Dako reference number: CAPA00475

Urgent Medical Device Field Safety Notice

Figure 1. Picture of stopcock spare part to Autostainer

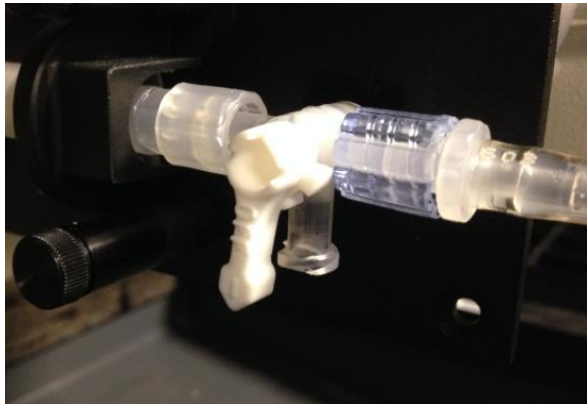
Dako has determined that a defect in the stopcock component of the syringe assembly (see figure 1) in some Autostainer instruments may, under some circumstances, cause leakage of excess buffer onto slide position 35 and 36 (for AS480 slide position 34) due to the stopcock's standby location over these position(s).

Dako has identified a longer term corrective action to install a drip tray under the stopcock. Your local Dako representative will contact you when the drip tray is available.
